FINAL DRAINAGE REPORT FOR NORTHERN DELIVERY SYSTEM BOOSTER PUMP STATION

April 2023

Project 224.29

Add PCD File No. PPR2262

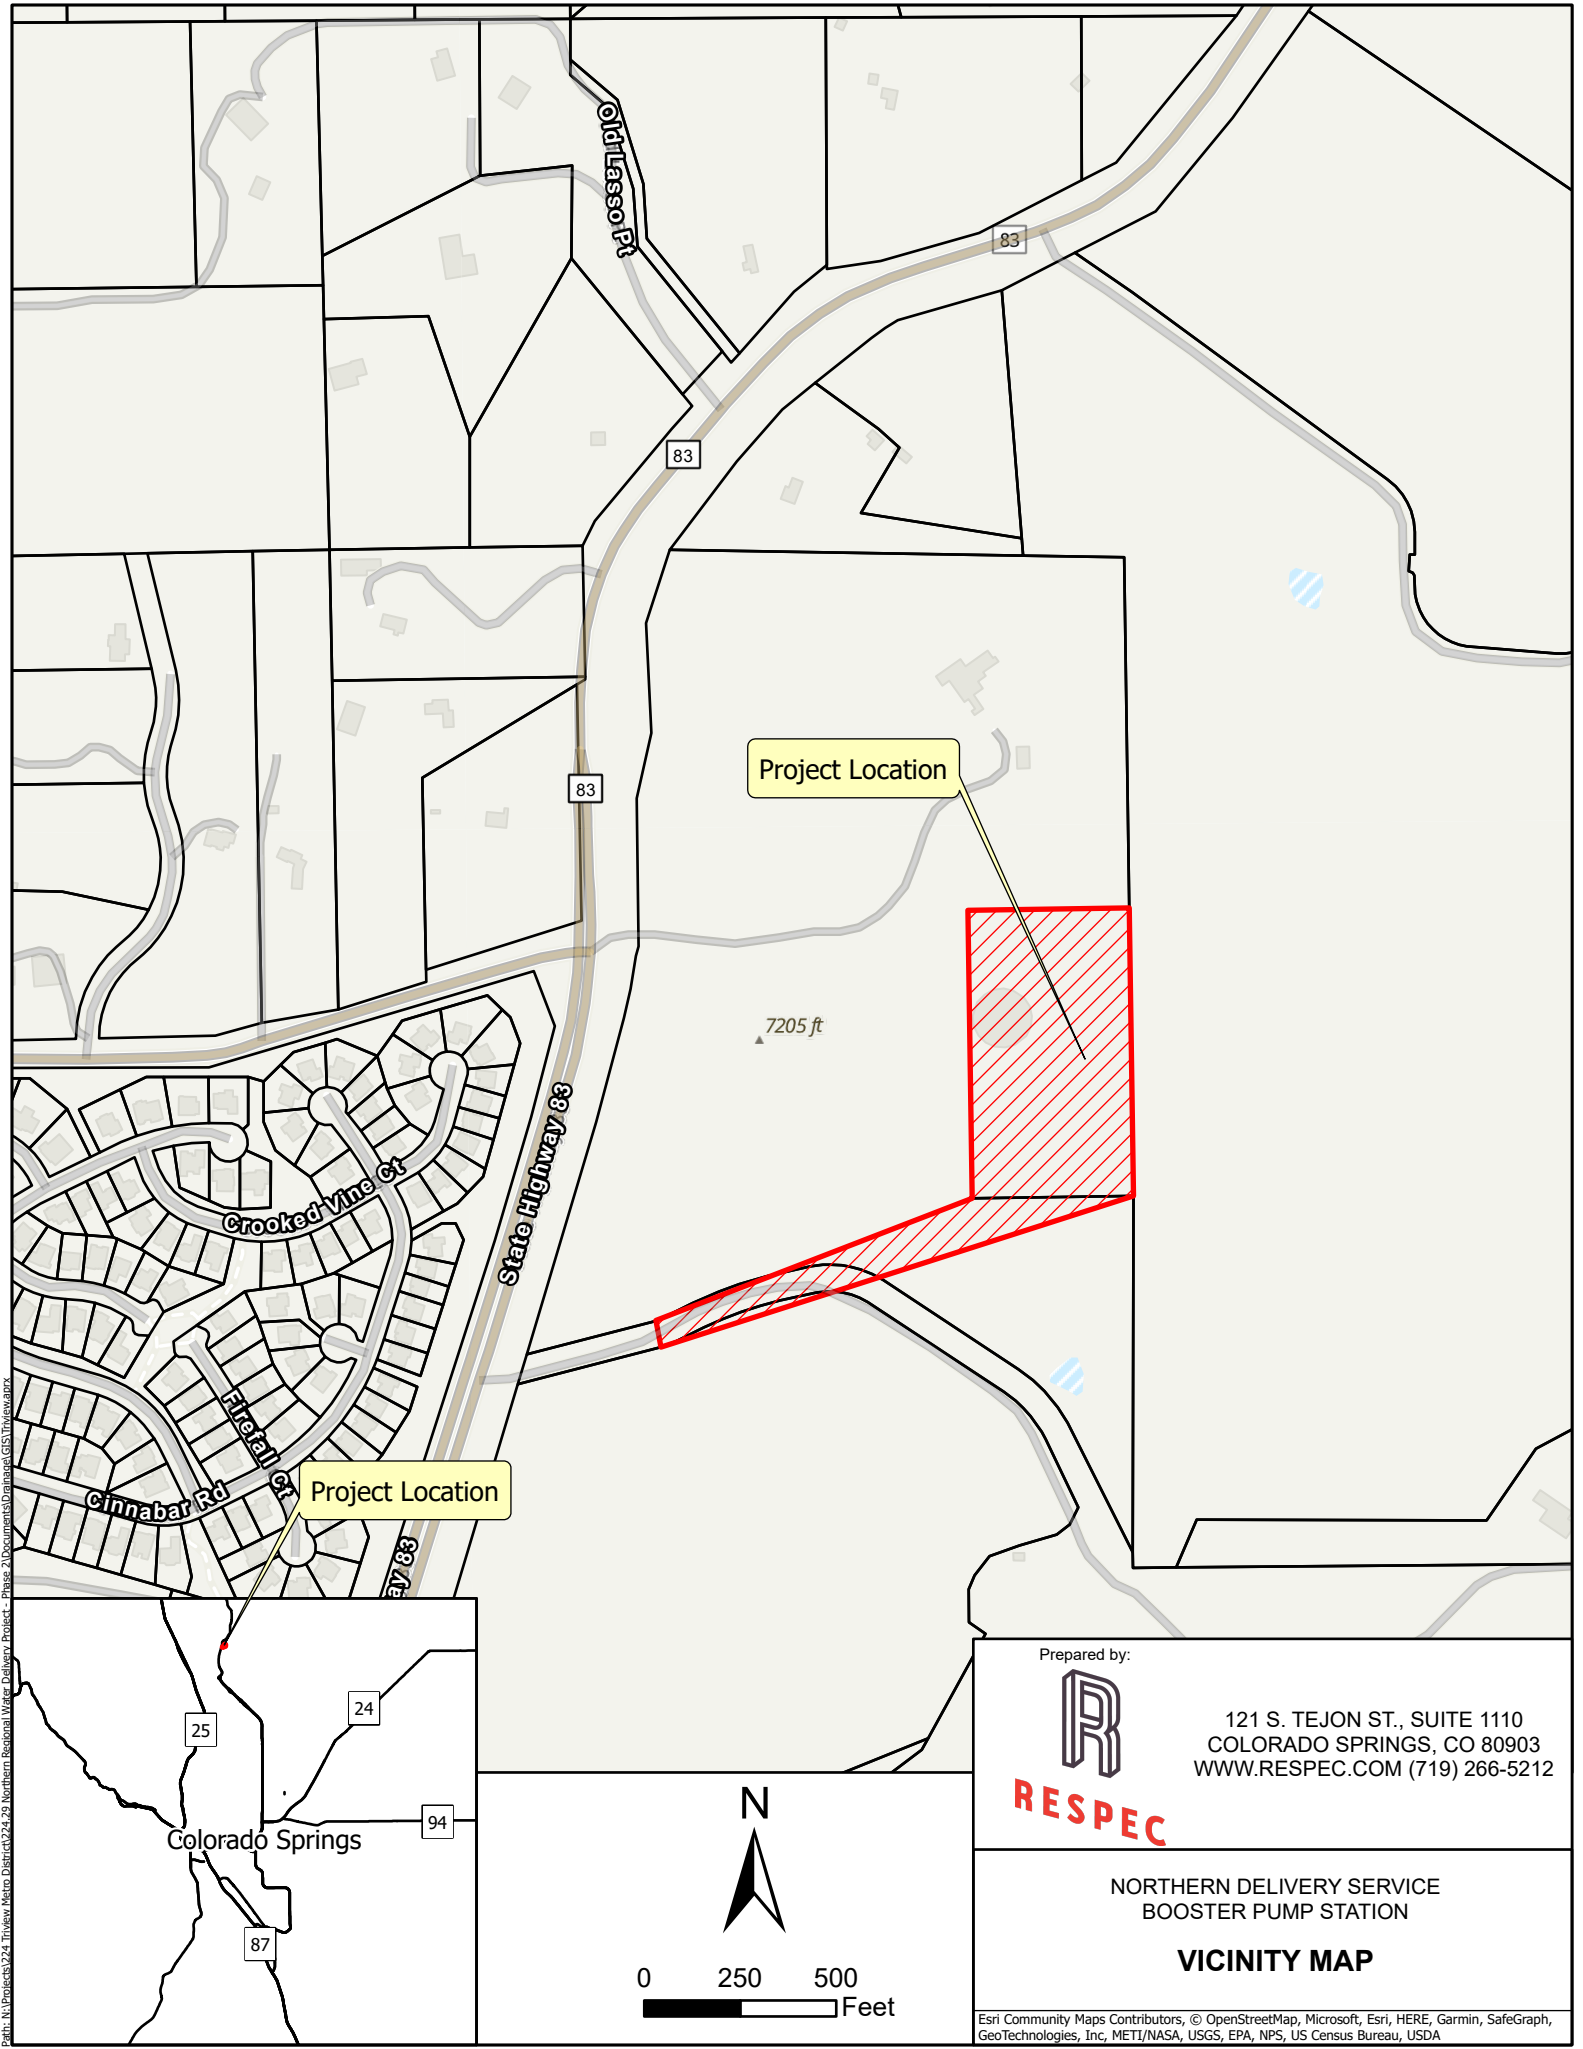
Show the "Four-Step Process" for selecting structural BMPs (ECM Section 1.7.2 BMP Selection). Under each step, summarize how the step was considered or implemented.

(Employ runoff reduction practices, stabilize drainageways, provide WQCV, and other specialized BMPs)

unresolved.
